15 November 2022  
Our Ref: 21788A.2NB (S4.55(2))

**RE: SECTION 4.55(2) APPLICATION TO MODIFY (MODIFICATION No. 2)  
DEVELOPMENT CONSENT SSD-11920082  
HASTINGS SECONDARY COLLEGE – PORT MACQUARIE CAMPUS  
16 OWEN STREET, PORT MACQUARIE**

Figure 3 Proposed Owen Street, PCYC elevation

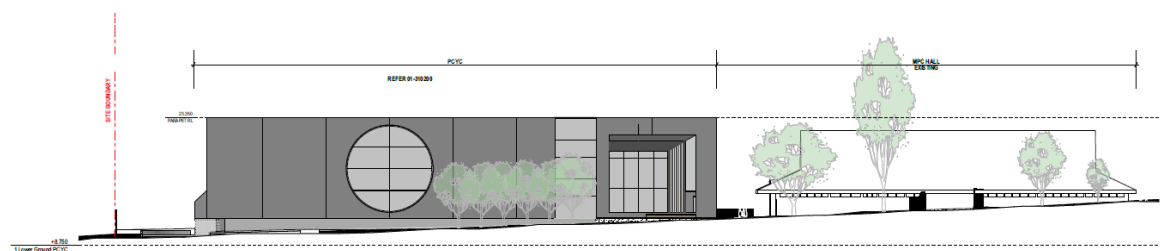
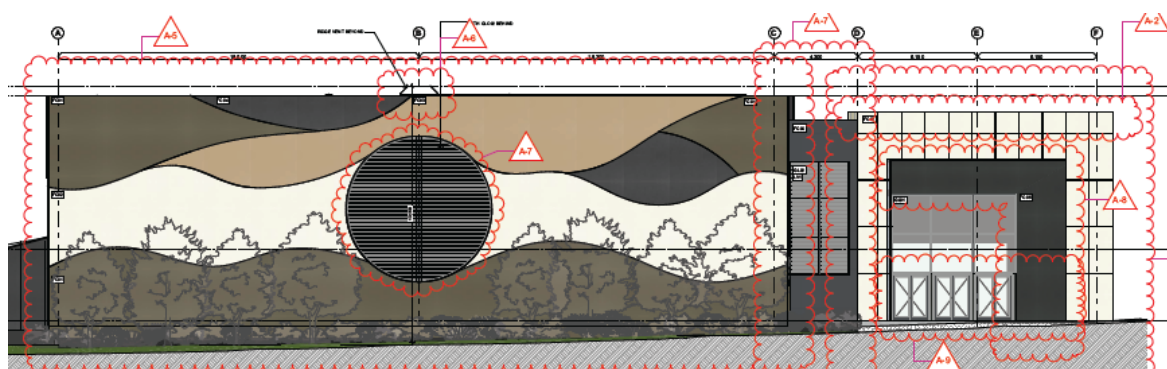
The proposed external alterations will alter the Owen Street streetscape through the change in building material, new driveway (being a replacement of the basement driveway) and additional landscaping. The 14 roof ventilators are not visible from the streetscape as they are behind the

approved parapet. The additional 8 ridge top ventilators are visible from Owen Street but are minor elements and low in height.

Overall, the modifications have minimal visual or height impact to the streetscape when compared to the approved design. The approved height of the development is 13.88m. The height of the PCYC with the roof ventilation is 13.16m. **Figures 2** and **3** are comparisons of the Owen Street elevation with **Figure 2** being the approved elevation and **Figure 3** incorporating the proposed modifications.

Figure 5 Modified PCYC Landscape

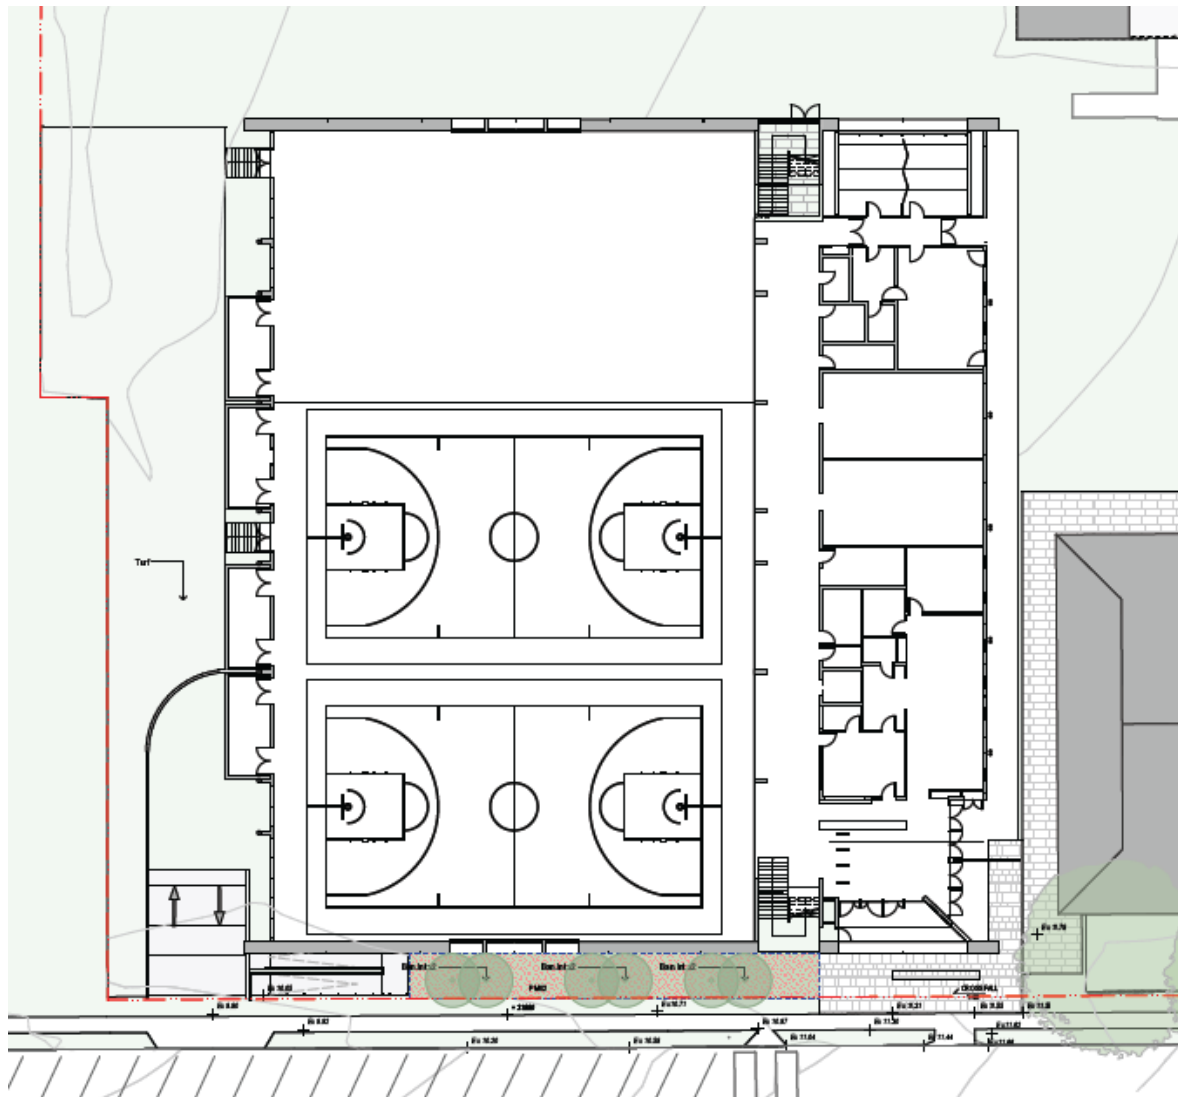
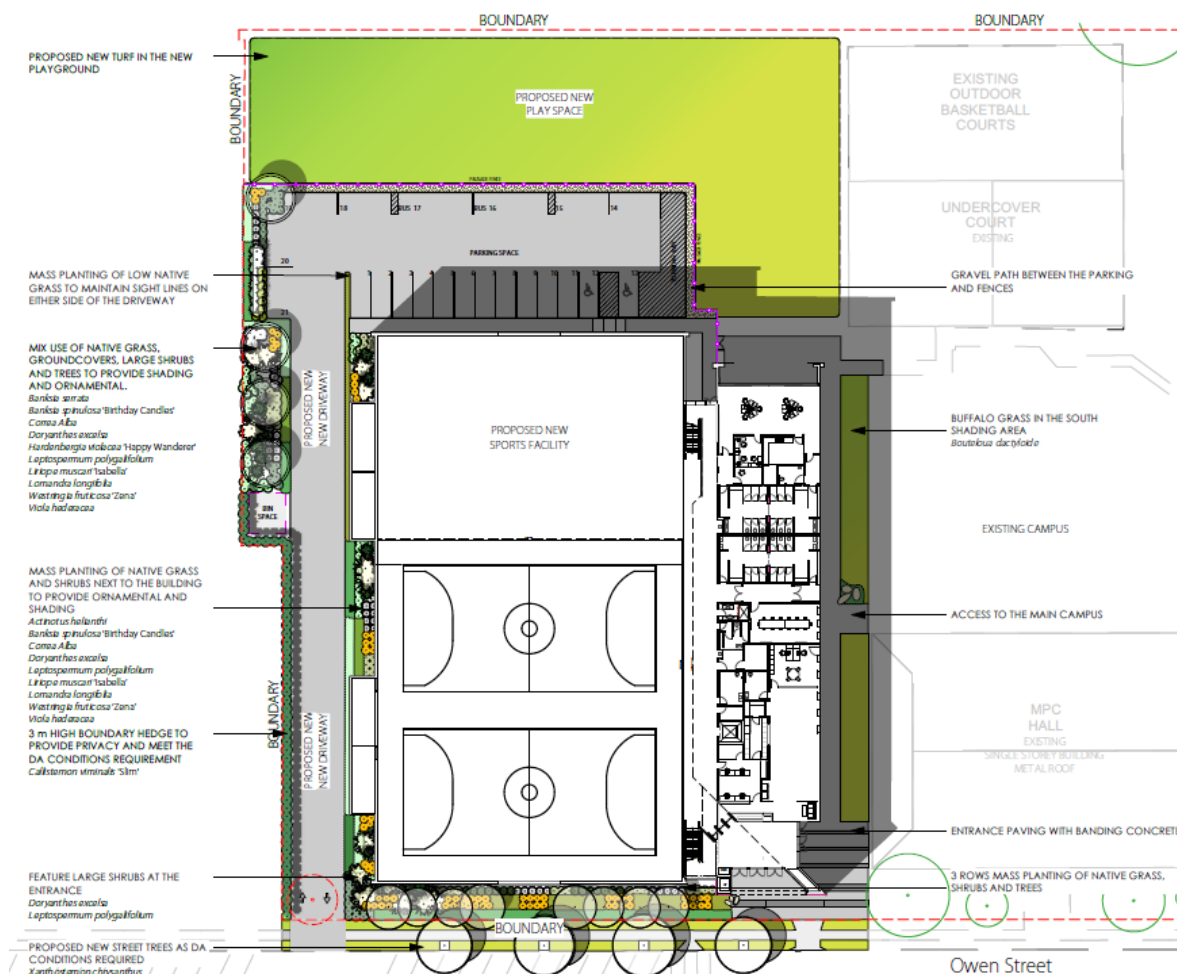
**Figures 4** and **5** are comparisons of the approved landscaping and proposed landscaping/ at grade carpark, with **Figure 4** being the approved design and **Figure 5** incorporating the proposed modifications. Open space is provided at 1715m<sup>2</sup> to the rear of the PCYC and landscaped area around the PCYC is 580m<sup>2</sup>.
